ZONING BOARD OF ADJUSTMENT, PANEL A
TUESDAY, AUGUST 19, 2014
AGENDA

UNCONTESTED CASES

REGULAR CASE

LANDSCAPE PLAN
SCALE: 1" = 10'-0"

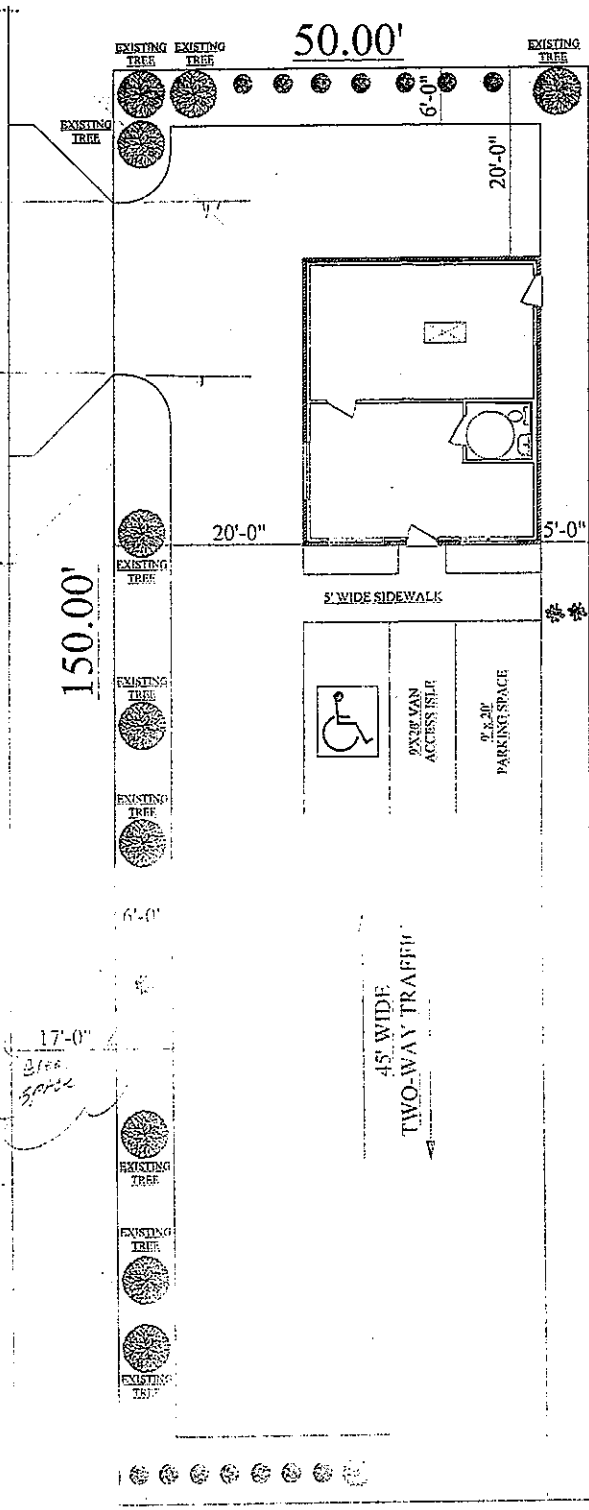
The landscape plan provides for the minimum requirement for street trees, site trees, and parking lot trees. The property is in a CR district with residential adjacency to the west and south of the site. The streets are unimproved (without curb and gutter).

During the process of construction, the applicant made changes to the structure and vehicular surface areas that are not conforming to the original approved plans. The landscape was red-tagged during inspection on May 22, 2014. The building permit is currently under review for an addendum to authorize adjustments to the building and alterations which places impervious surface into the mandatory buffer. The current

The landscape plan makes good use of existing hackberry trees along Georgia Street and along the west buffer. New plantings, parking, or other items that create obstructions from 2.5' to 8' above the street grade at the property, cannot be provided in the visibility triangle at Ewing and Georgia. Existing trees may be maintained to be in compliance with city regulations for site visibility and street clearance.

The plan does not indicate the form of irrigation for new plants to be planted along the perimeter.

The plan does not account for full Article X design standard options, but it appears space could be presented for addressing screening of off-street parking (by minimum 3-foot tall fence or shrub row) and/or foundation planting along one or two sides of the structure, if the owner is amenable to further site amendment.

The chief arborist recommends denial of the presented plan because the applicant has not demonstrated how strict compliance of the Article X requirements will unreasonably burden the use of the property. A plan was originally presented to indicate how the office site could comply with the mandatory and design standard provisions of the ordinance. The site has since been modified. In accounting for the reduced landscape area by the encroachment, I cannot explain how the increased impervious surface is applicable to the office use on the property. However, I do not believe a special exception will adversely affect neighboring property if improvements are properly maintained.
